PART 573 Defect and Noncompliance Report

Manufacturer's corporate name: OBS INC.

**Subject: Dometic Corporation Recreation Vehicle Power Awning Recall Notification**

#### 9100 POWER AWNING, WEATHERPRO AWNING AND MOTOR SERVICE KITS

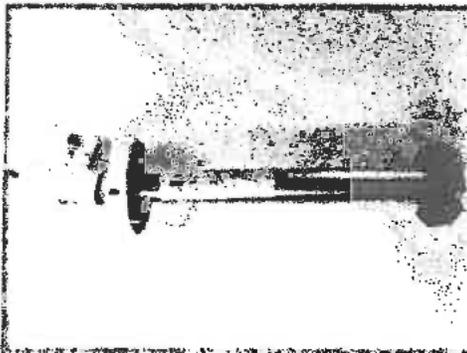
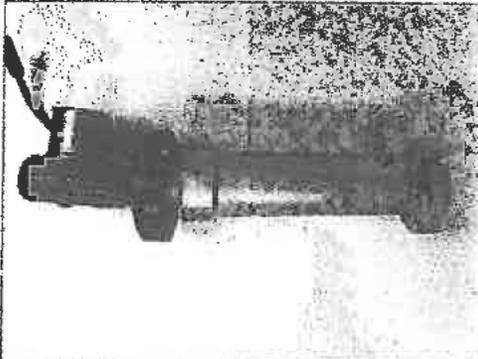
**Awning Motor –**  
Pre February 13, 2013. This motor  
is not affected by the product  
recall.

**Awning Motor –**  
This motor is affected by the  
product recall.  
Serial Range 306xxxx to 314xxxx  
Manufacturing Date Range  
02/13/2013 to 04/09/2013

**Awning Motor –**  
Post April 9, 2013. This motor is  
not affected by the product recall.
